**STAFF REPORT**  
**(One-Step Final Plat)**

**CASE NUMBER:** SUB 2005-23 -- OSBECK ADDITION

**LOCATION:** West of Tyler, South of Kellogg

**VICINITY MAP**

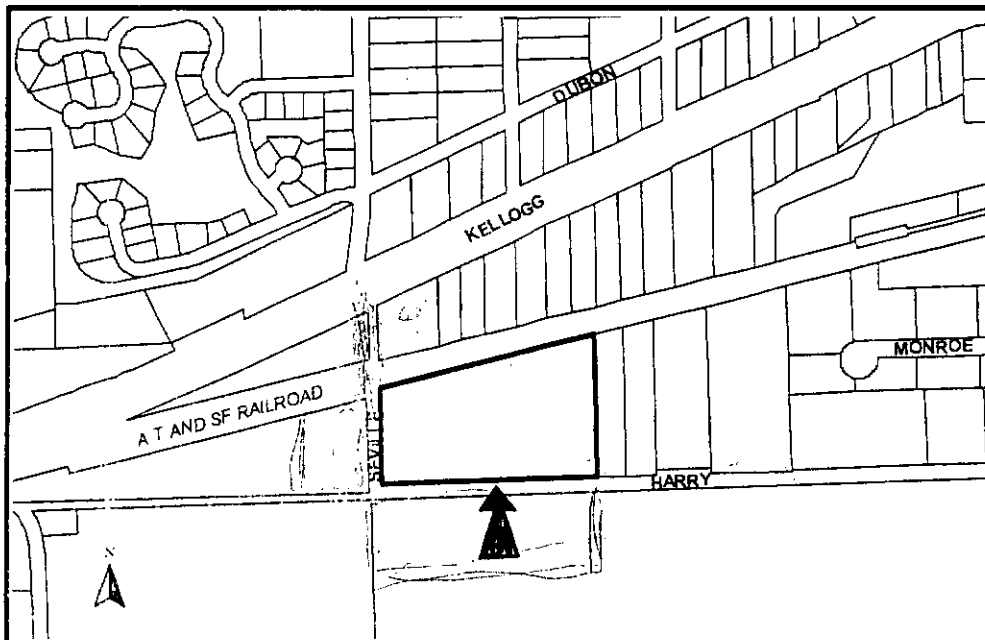
- I. The vicinity map needs to be corrected.
- J. The signature line for the Deputy within the Register of Deeds certificate needs to be revised to reference "Tonya Buckingham".
